SUBMITTAL REVIEW

Project MCOC East Wing

K&L Shop Dwg. N° E-19

Title Sketch SK-1, Underground
Primary Feeders Installation

4/3/03 SKETCH # SK-1

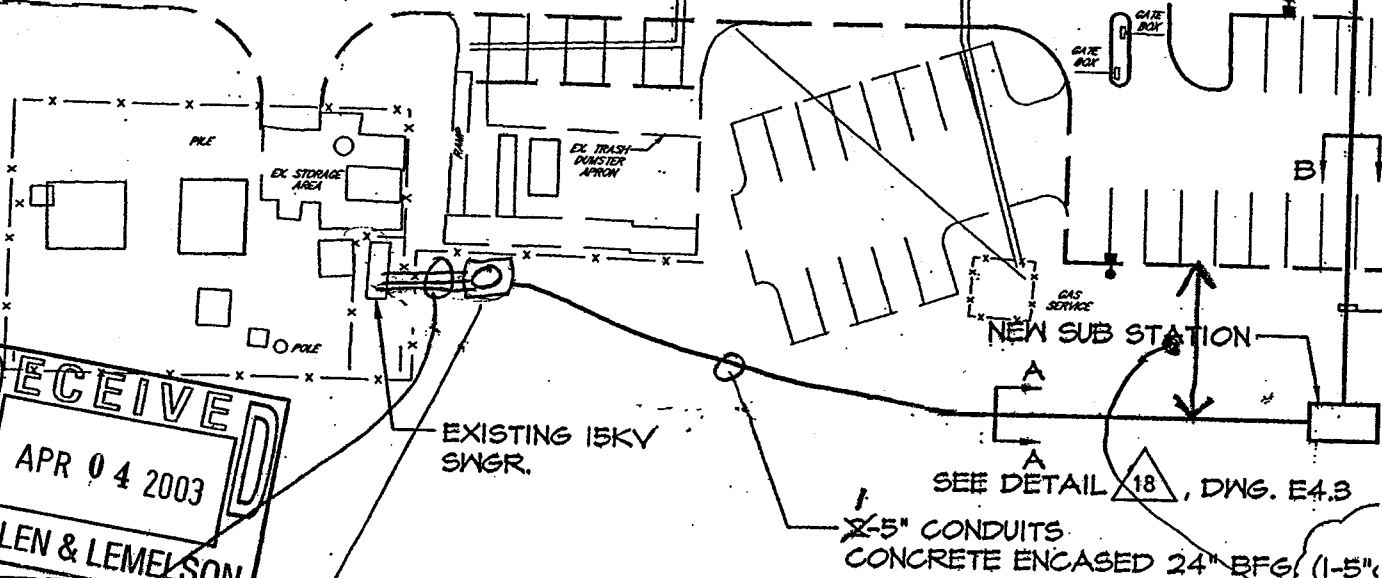
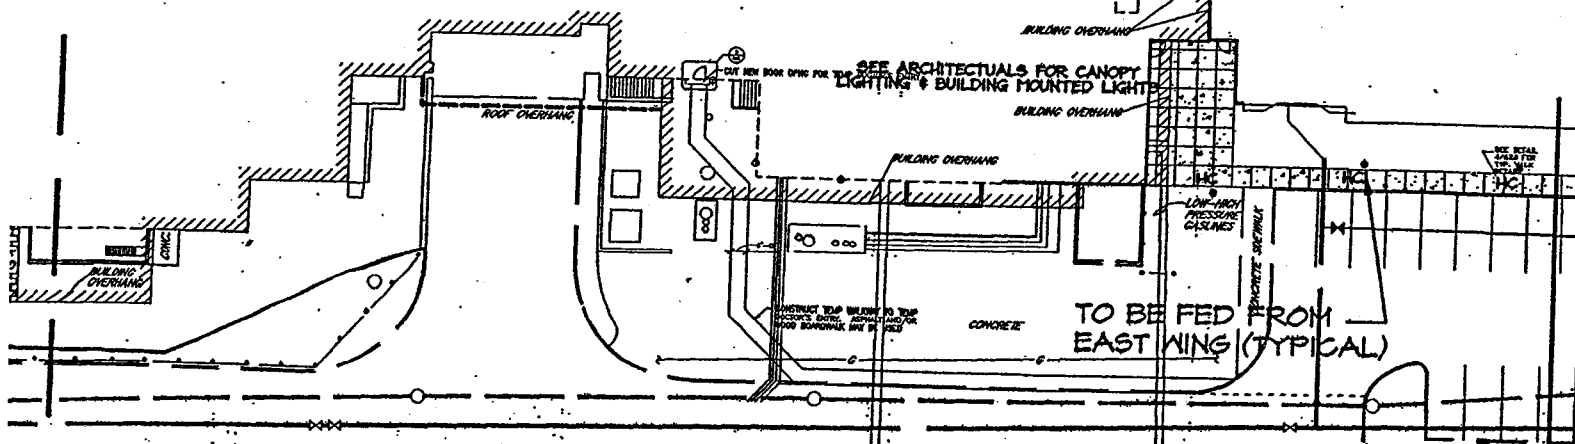
- A. Coordinate route with Site Engineer, GC and Architect. *← SEE Attached From H&L*
- B. Coordinate route with the existing underground utilities.
- C. Coordinate substation concrete pad sleeves location with the substation compartments layout for HV and LV sides.

Per our conversation on April 15, 2003 and subsequent telephone conversations, we find the proposed relocation of the electrical is acceptable. The electric is relocated to avoid conflicts with the existing trees. This electric should be installed in accordance with all applicable codes.

4/3/03 SKETCH # SK-1

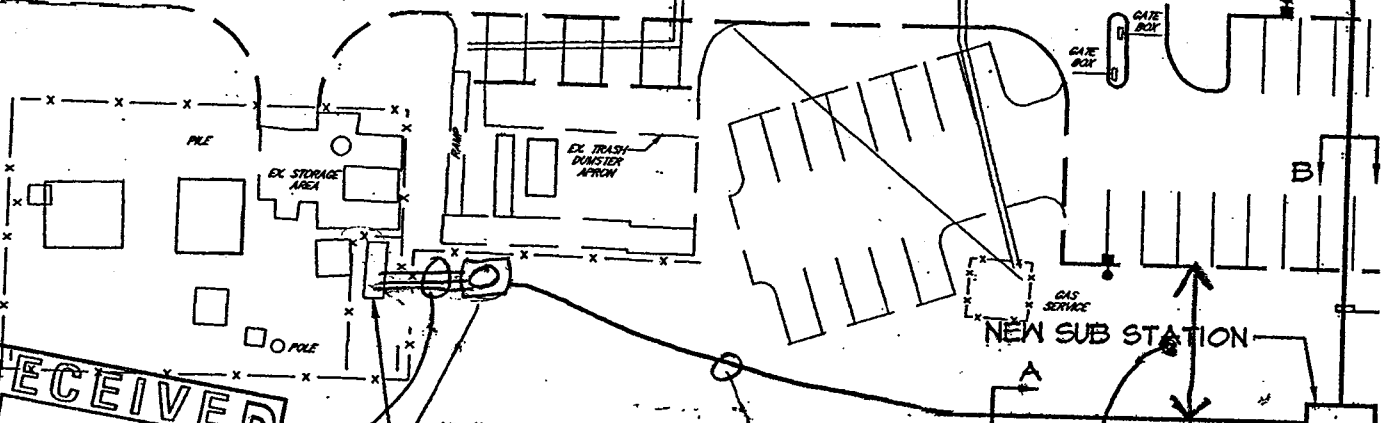
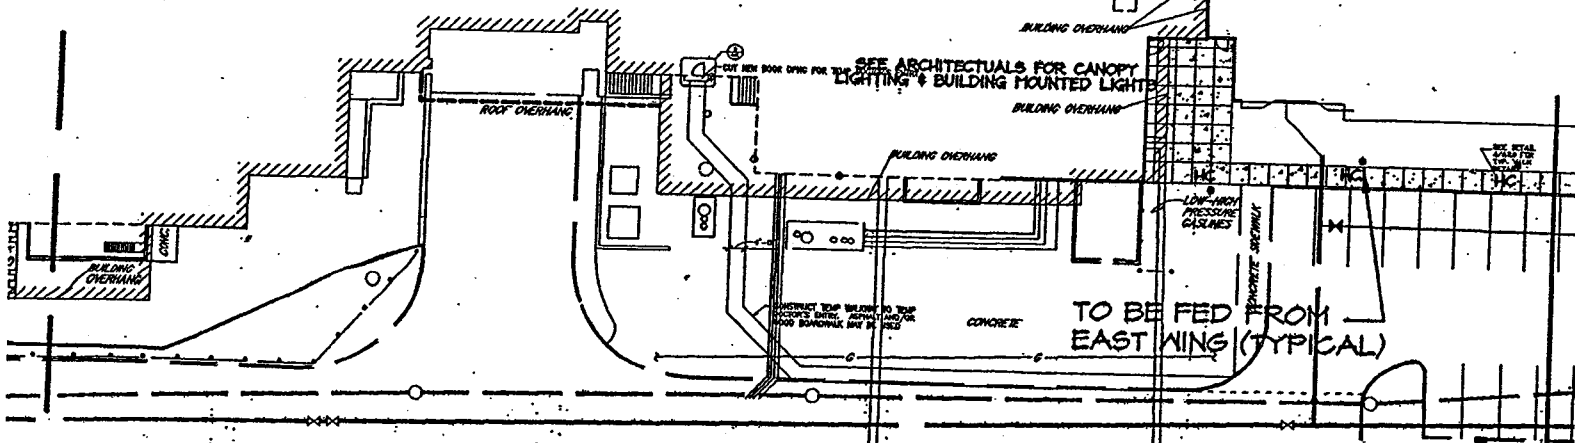
- A. Coordinate route with Site Engineer, GC and Architect. ← *SEE Attached From H&L*
- B. Coordinate route with the existing underground utilities.
- C. Coordinate substation concrete pad sleeves location with the substation compartments layout for HV and LV sides.

SEE DETAIL 18, DWG. E4.3
2-5" CONDUITS
CONCRETE ENCASED 24" BFG (1-5")

Per our conversation on April 15, 2003 and subsequent telephone conversations, we find the proposed relocation of the electrical is acceptable. The electric is relocated to avoid conflicts with the existing trees. This electric should be installed in accordance with all applicable codes.
